Access Compliance Report

Public Rights-of-Way

Intersection ID: 31585	Main Street: NAPTON_CT	Cross Street: PATTONSBURG_DR	Location: SW
ADA ID: 779488B0FD42	Ramp Type: PerpDiag	Initial Pass/Fail: Fail	Overall Compliance: No
Codes/Mitigation Info/Possible Solution		Field Measurements/Component Compliance	
Severity Score: 10

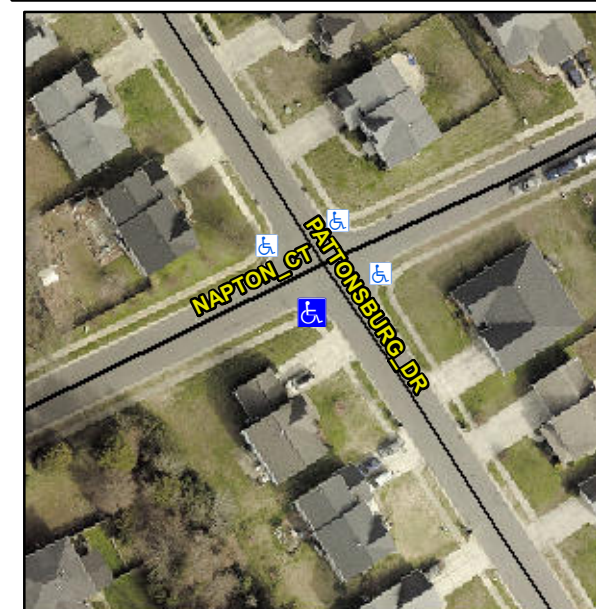
Not Found, R304.5.1, R304.5.3

Compliance	Description	Data	Compliance	Description	Data
N/A	Ramp Length (in)	41.0	Yes	Ramp Slope (%)	7.8
No	Ramp Width (in)	47.5	No	Ramp XSlope (%)	2.1
N/A	Flare Type LT	N/A	N/A	Flare Type RT	N/A
N/A	Flare Slope LT (%)	N/A	N/A	Flare Slope RT (%)	N/A
N/A	Flare Traversable LT?	N/A	N/A	Flare Traversable RT?	N/A
N/A	Landing Length (in)	N/A	N/A	DWS Provided?	N/A
N/A	Landing Width (in)	N/A	N/A	DWS Contrast?	N/A
N/A	Landing Slope (%)	N/A	N/A	DWS Length (in)	N/A
N/A	Landing X Slope (%)	N/A	N/A	DWS Full Width?	N/A
N/A	Landing Curb? (Y/N)	N/A	N/A	DWS Offset (in)	N/A
N/A	Shared Landing?	N/A			
N/A	Gutter Ponding?	N/A	N/A	Gutter Slope (%)	N/A
N/A	Gutter Lip Ht (in)	N/A	N/A	Gutter X Slope (%)	N/A
N/A	Painted X Walk1?	No	N/A	Painted X Walk2?	No
	X Walk 1 Direction	To E		X Walk 2 Direction	To N
N/A	X Walk 1 Width (in)	N/A	N/A	X Walk 2 Width (in)	N/A
	X Walk 1 Slope (%)	3.6		X Walk 2 Slope (%)	2.9
	X Walk 1 X Slope (%)	2.5		X Walk 2 X Slope (%)	1.3

Remove & Replace Curb Ramp With Two New Directional Ramps or Equivalent.
